E4419B-19B

S E R V I C E N O T E

Agilent E4419B EPM Power Meter

Hot plugging problem caused by analog switches (U11) under the measurement board assembly (E4418-60007)

Figure 1: No sensor is detected while sensor is connected

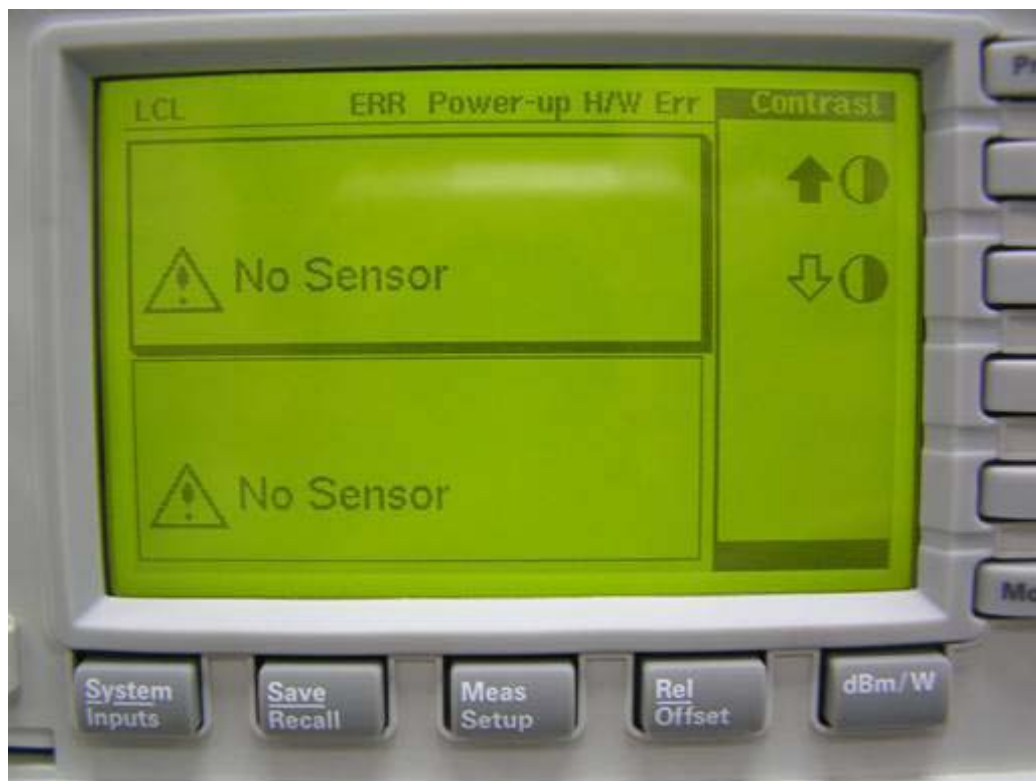
This problem happened on power meter E4419B where the power meter will be hang up from time to time and an error message will be displayed. This problem can be duplicated by performing the following steps:

1. Power On the power meter.
2. Connect a power sensor to the power meter.
3. With the power meter still powered, directly unplug the power cord from the power meter.
4. When power cord is plugged back to the power meter, error message will appear in the front display of the power meter as shown in Figure 1.
5. To get the power meter in operation mode again, manually press PRESET button on the power meter's front panel.

It has been found that analog switch (U11) is causing the hot plugging problem. There are 3 different suppliers who are supplying this part: Analog Device, Vishay and Intersil suppliers. The analog switch supplied by Vishay was found to be contributing to the hot plugging problem. It was a batch related issue that happened in 2005. Current parts do not have this failure.

Replace the problematic measurement board with a good measurement board. After replacing the measurement board, repeat the steps mentioned above to verify that the problem is resolved. It should indicate that sensor is connected even after hot plugging.
